ADDENDUM NO. 2

TO: PLANS AND SPECIFICATIONS FOR STATE OF MISSOURI

HVAC Improvements for Infection Control
Mexico Veterans Home
Mexico, Missouri
PROJECT NO.: U2301-03

Sheet S-151 Detail #1

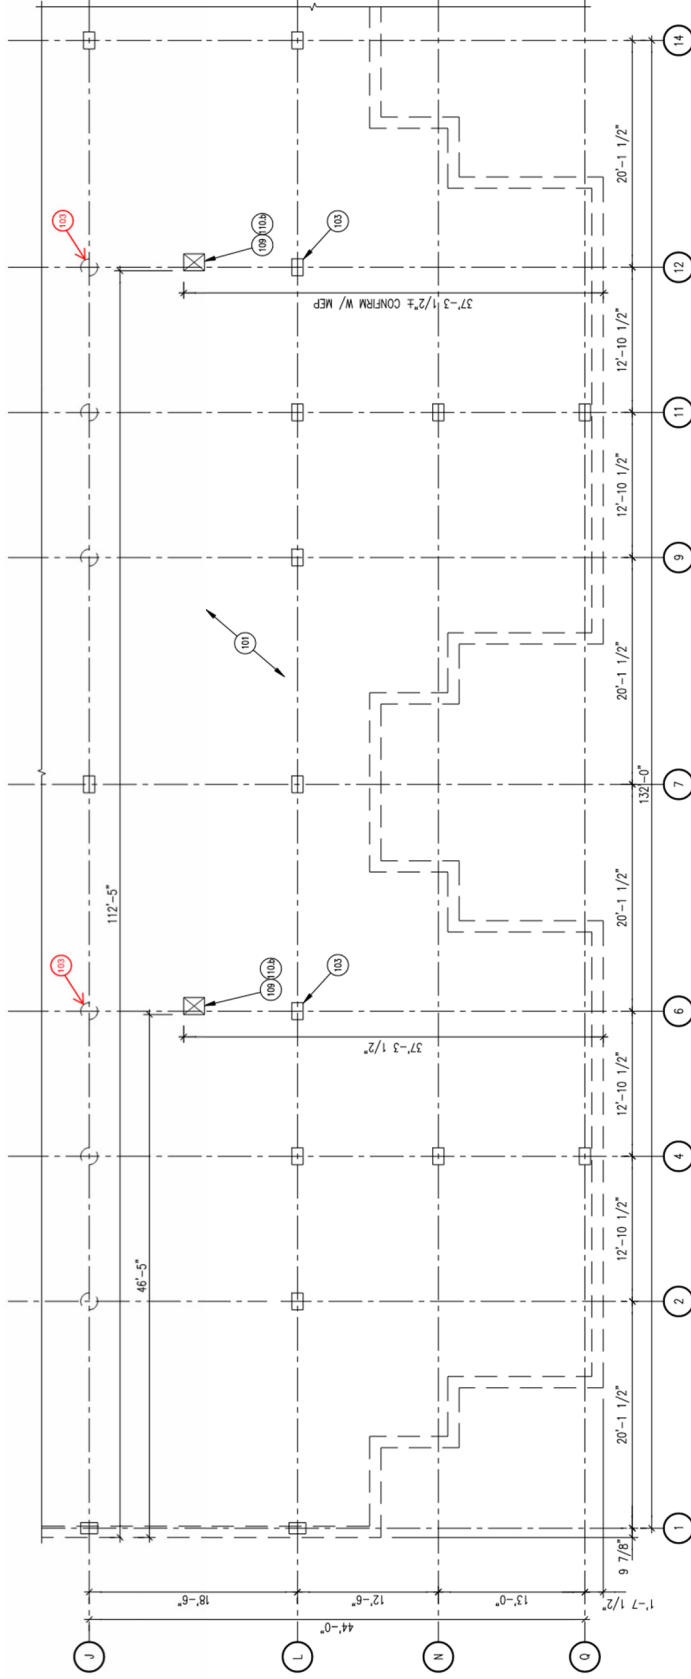
1. Sheet S-151 – See Attached details 1 and 2 on sheet S-151
 - a. Detail 1: Keyed note 103 is not required at column 2-L.
 - b. Additional keyed note 103 call outs were added to provide clarity.
2. Sheet A-401 – See Attached details A, C, and Window Schedule on sheet A-401
 - a. Removal of plywood from casement frame on windows W1 and W6 has been removed from scope of work.
3. Sheet A-402 – See Attached details A, C, and Window Schedule on sheet A-402
 - a. Installation of new glazing within casement frame on windows W1 and W6 has been removed from scope of work.
